• **ELECTRICAL—LAMP—TRANSMISSION CONTROL INDICATOR LAMP (TCIL) ILLUMINATED—DIAGNOSTIC TROUBLE CODE (DTC) P0741 AND/OR P1728—VEHICLES EQUIPPED WITH 5.0L ENGINE AND 4R70W TRANSMISSION ONLY** • **TRANSMISSION—4R70W—TRANSMISSION CONTROL INDICATOR LAMP (TCIL) ILLUMINATED—DIAGNOSTIC TROUBLE CODE (DTC) P0741 AND/OR P1728—VEHICLES EQUIPPED WITH 5.0L ENGINE AND 4R70W TRANSMISSION ONLY**	**Article No. 01-5-4**

FORD: 1998-2001 EXPLORER

MERCURY: 1998-2001 MOUNTAINEER

AUTHORIZED MODIFICATIONS

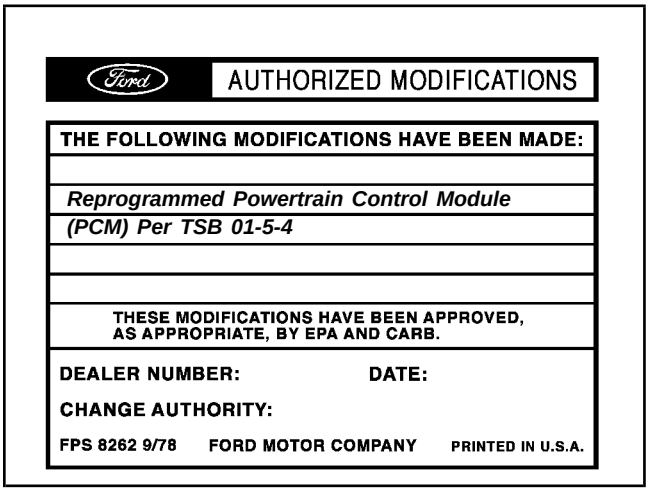
Obtain an Authorized Modifications Decal (FPS 8262 - obtainable through DOES II, 25/pkg) and list the date, dealer number, and summary of modifications performed. Select a prominent place adjacent to the Vehicle Emission Control Information Decal suitable for installing the Authorized Modifications Decal. Clean the area, install the decal, and cover it with a clear plastic decal shield.

Reprogrammed Powertrain Control Module (PCM) Per TSB 01-5-4
